**RE: Generations at West Mesa
5710 Avalon Rd NW
Grading and Drainage Plan
Engineer's Stamp Date: 04/11/18
Hydrology File: K11D084**

Based upon the information provided in your resubmittal received 04/17/2018, the Grading and Drainage Plan is approved for Building Permit and Grading Permit.

Cypress Civil Development has compiled the following responses to the comment letter received from City of Albuquerque Hydrology Department for the above mentioned project. The responses are listed by heading below:

Reservoir "PWS6 Basin" Results for Run "Run 1"

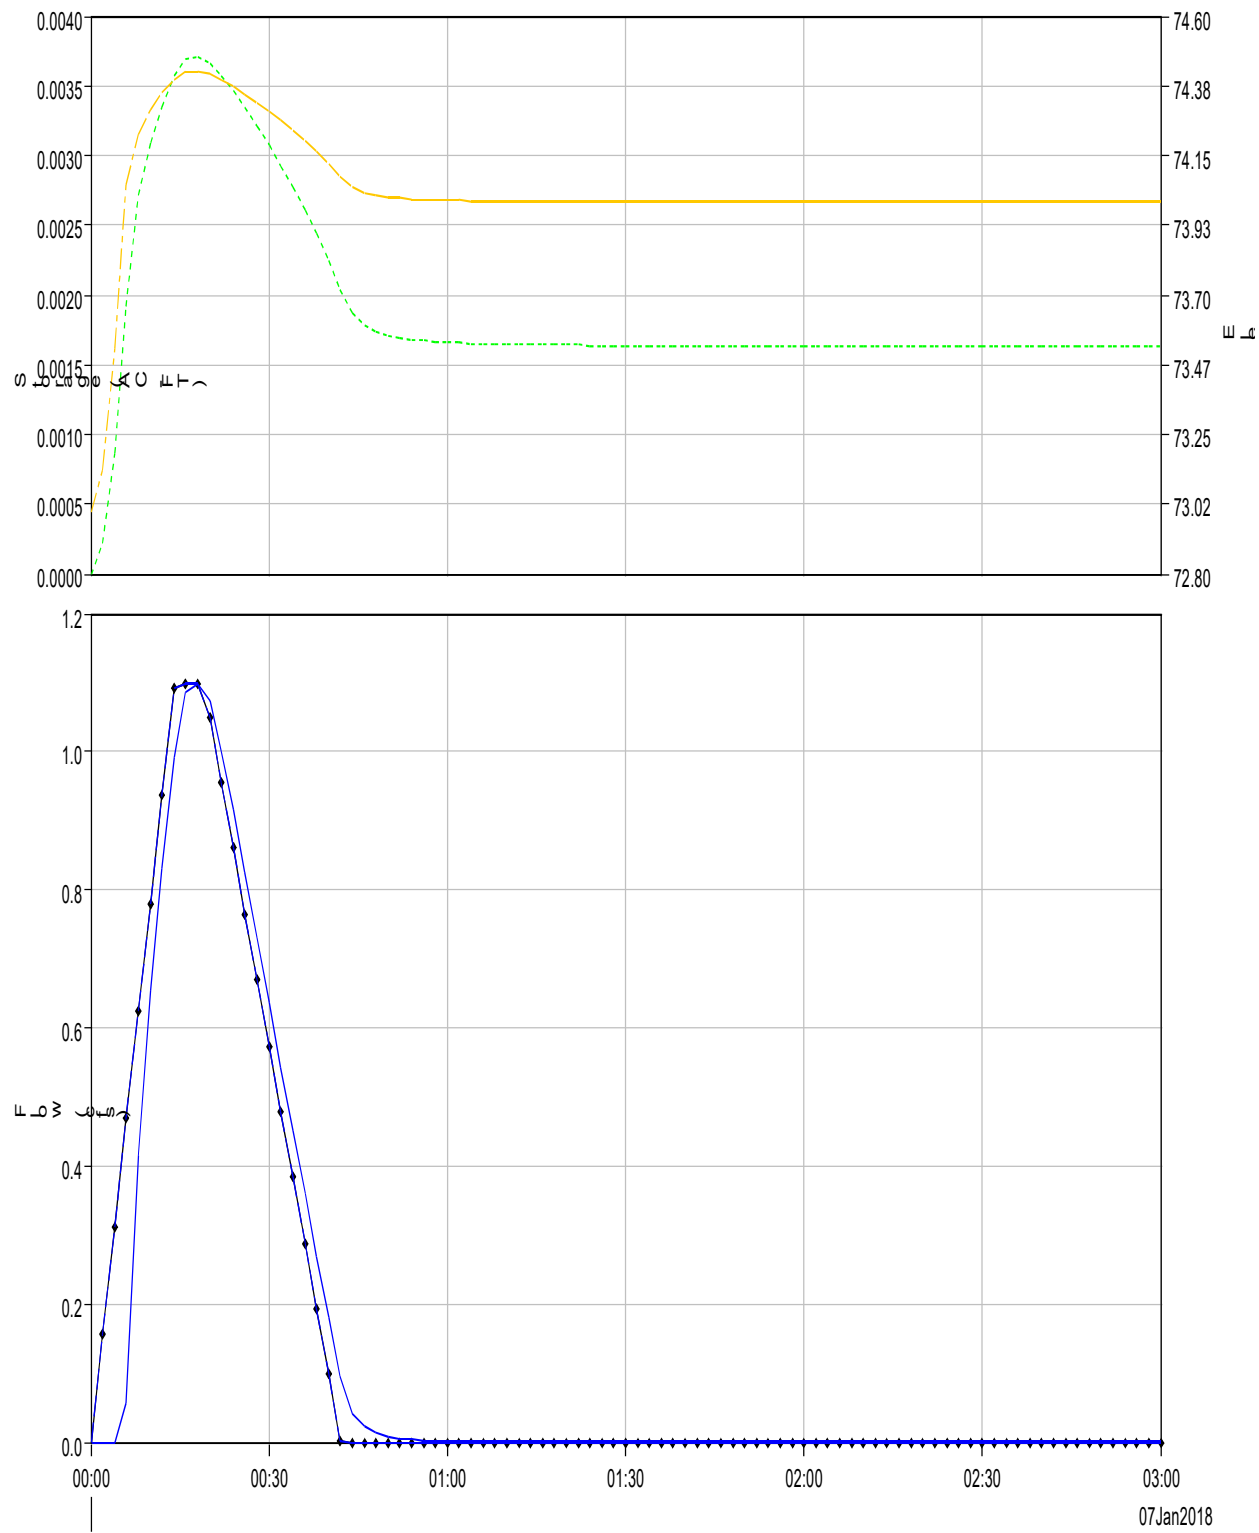
Comment 15 – Acknowledged. Per email discussions, HEC HMS was used to calculate the Q100 that discharges into the right-of-way from the proposed development. The proposed water harvesting/basin areas detain approximately 3.33 cfs, ultimately discharging approximately 10.5 cfs, the same as existing conditions.
